Bid Bulletin #1

PROJECT: Northeast Community College
Applied Technology Building, Physical Plant Building, Sitework

DATE: July 3, 2013

PHYSICAL PLANT / APPLIED TECHNOLOGY BUILDINGS CIVIL PACKAGE NORTHEAST
COMMUNITY COLLEGE
801 East Benjamin Avenue
Norfolk, NE 68702-0469
BCDM Project No. 3527-01

2 FOUNDATION PLAN - AREA 'B' ALT. AT-1
1/8" = 1'-0"

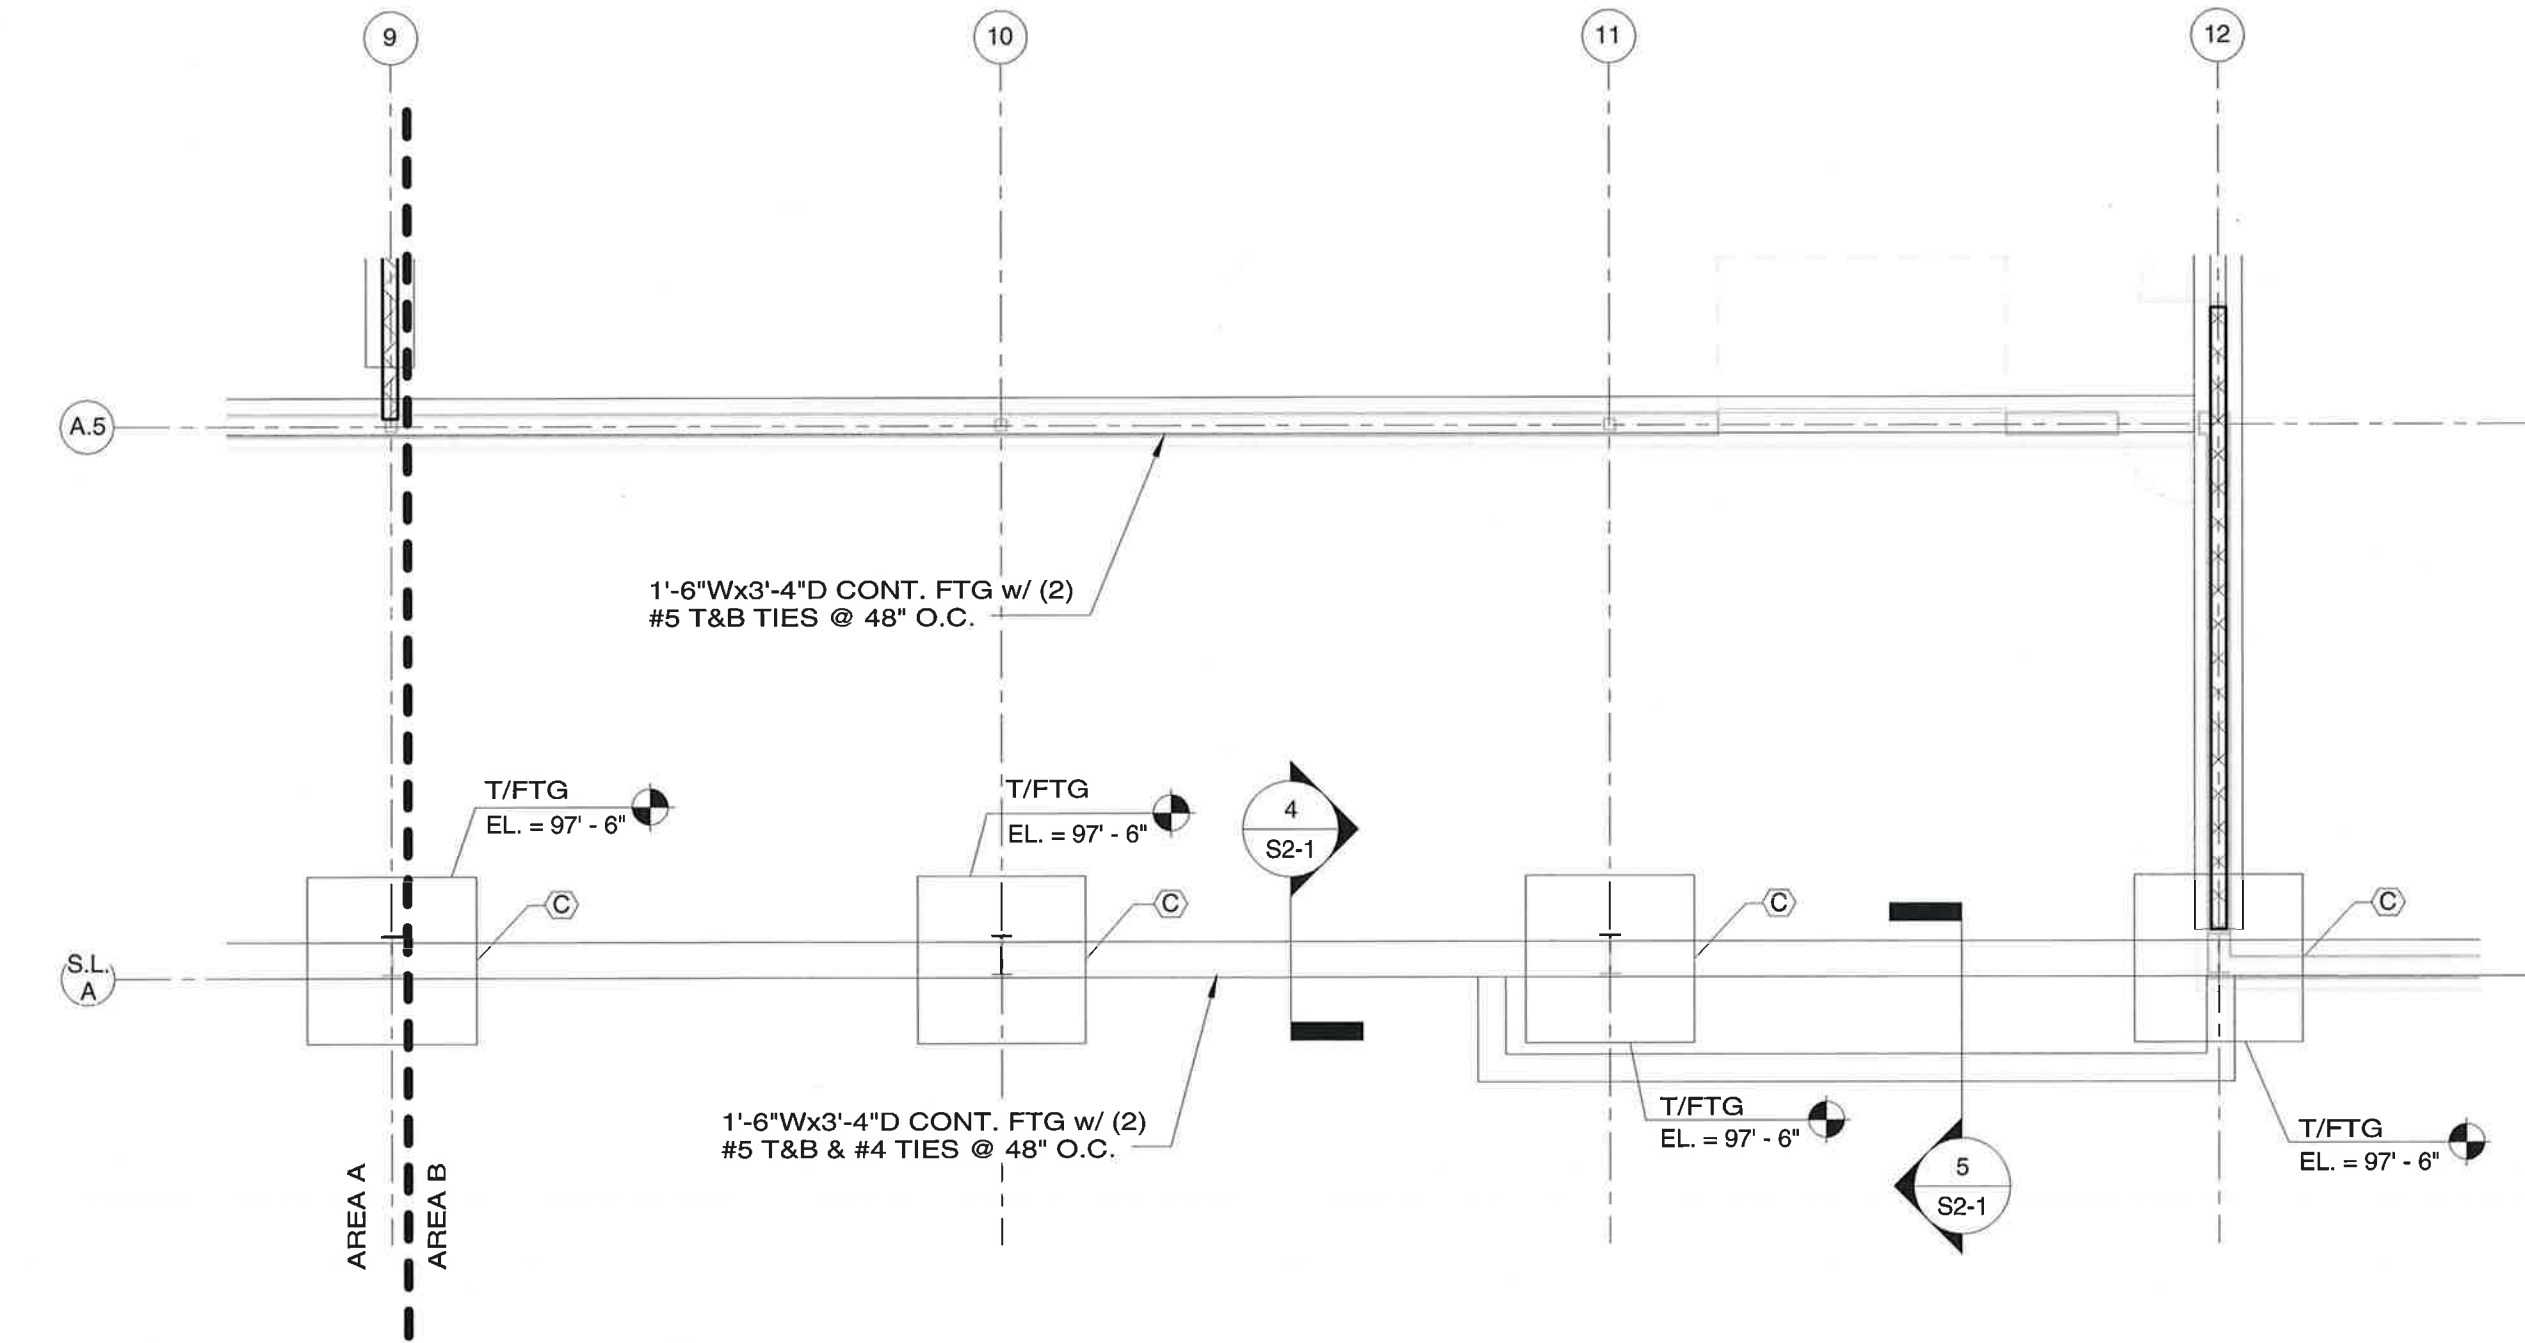
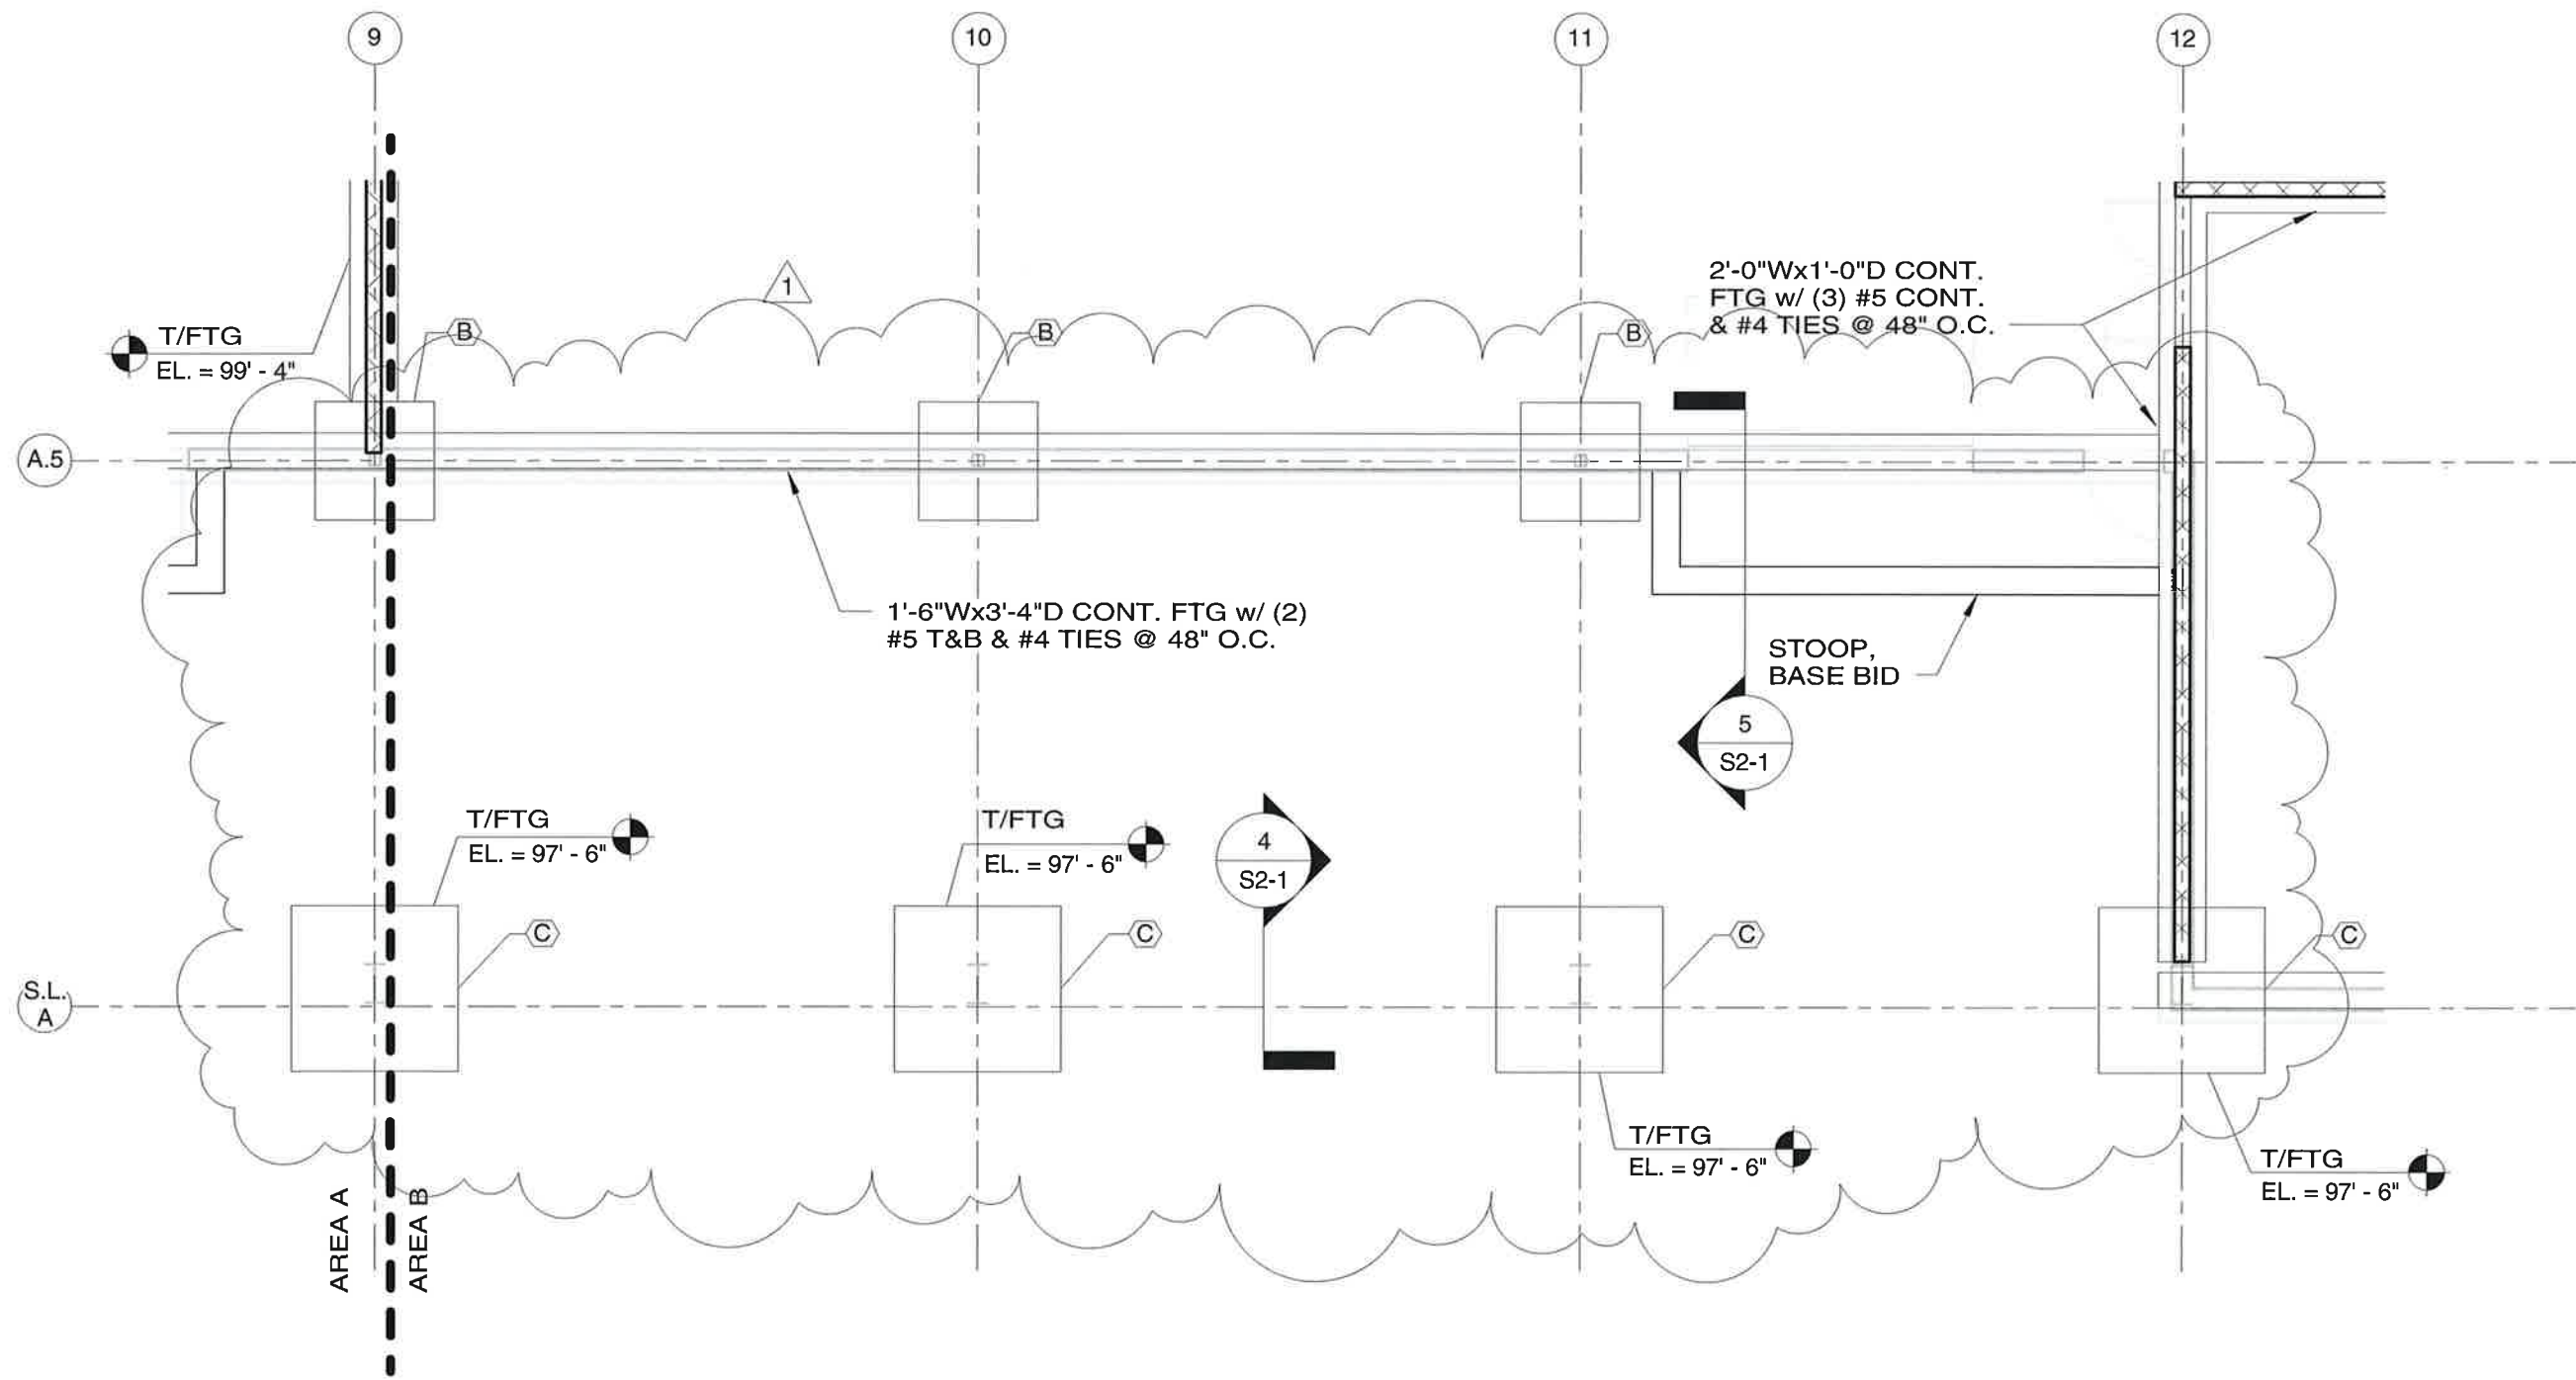
- a. Detail 1: Revise foundation plan as shown on attached partial plan SSD-4.
- b. Detail 1: Revise foundation plan as shown on attached partial plan SSD-5.
- c. Detail 1: Revise foundation plan as shown on attached partial plan SSD-7.
- d. Add Detail 2, PARTIAL FOUNDATION PLAN – Area 'B' Alt. AT-1, See SSD-2

DRAWING REFERENCED: A1-1A / A5-1A

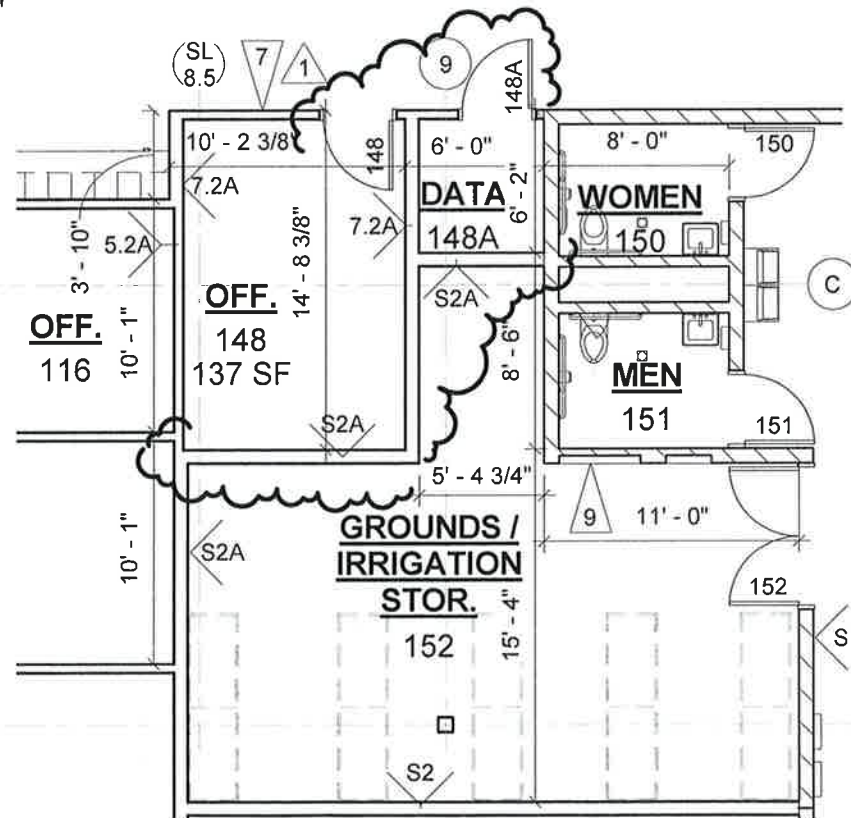
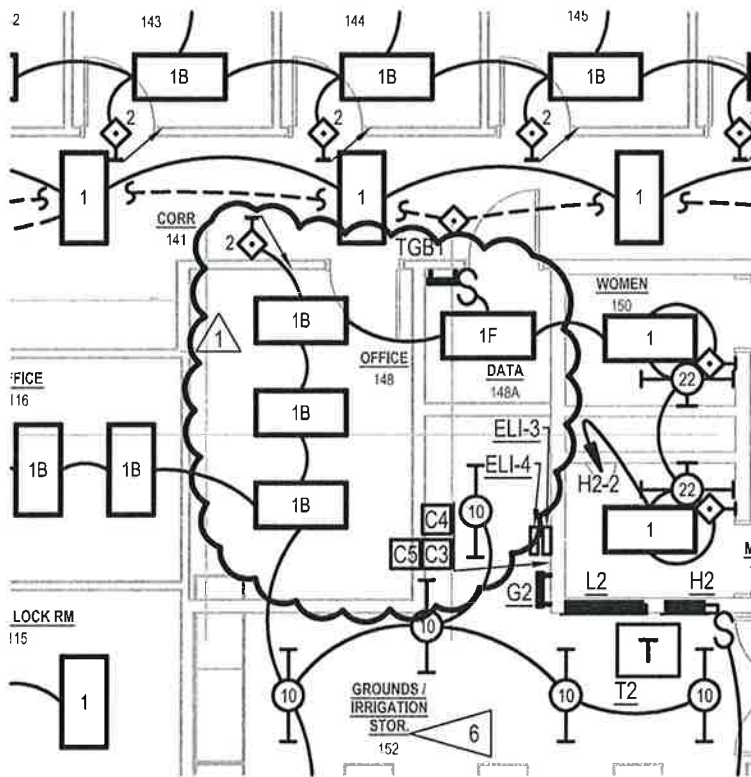
- a. Detail 1: Revise Office 148 and Data 148A layout per the attached Detail 1 on Sheet ASD-1.

- a. Detail 1: Revise Office 148 and Data 148A layout per the attached Detail 2 on Sheet ASD-1.

project no.: 12103	drawing referenced: E1-1A	E1-1Aa
date: 06/28/2013	addendum no.: 1

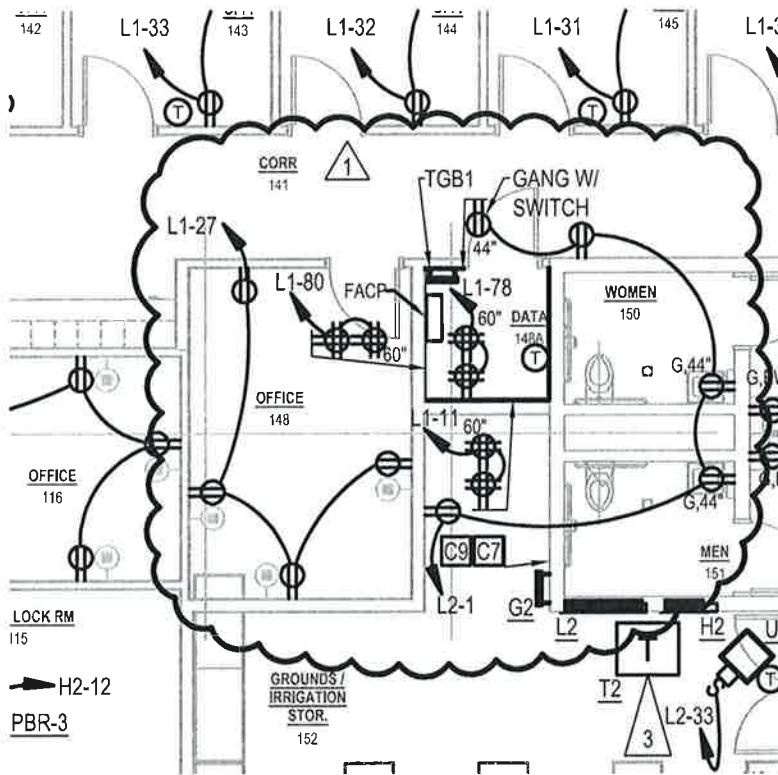
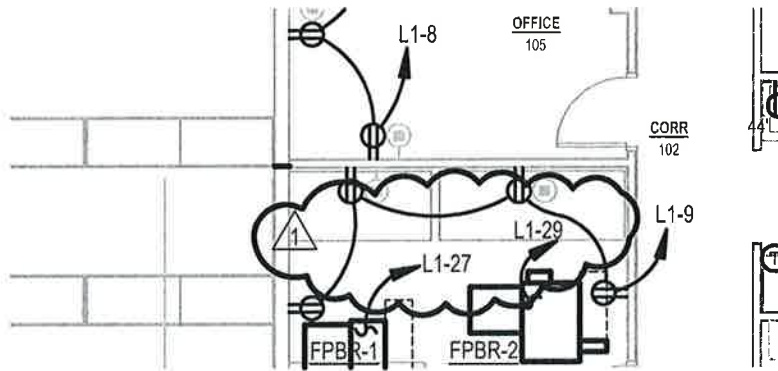
- 1. Sheet E1-1A Floor Plan - Lighting
 - a. See Sketch E1-1Aa
- 2. Sheet E2-1A Floor Plan - Power
 - a. See Sketch E2-1Aa
- 3. Sheet E3-1A Floor Plan - Special Systems
 - a. See Sketch E3-1Aa
- 4. Sheet E4-1
 - a. For Power Riser Diagram feeder 125-3 provide 3-#1, #6 G. - 1-1/2" C.
- 5. Sheet E4-2
 - a. Fixture schedule: Fixture types 7, 8, and 9 shall be considered equal as manufactured by Focal Point.
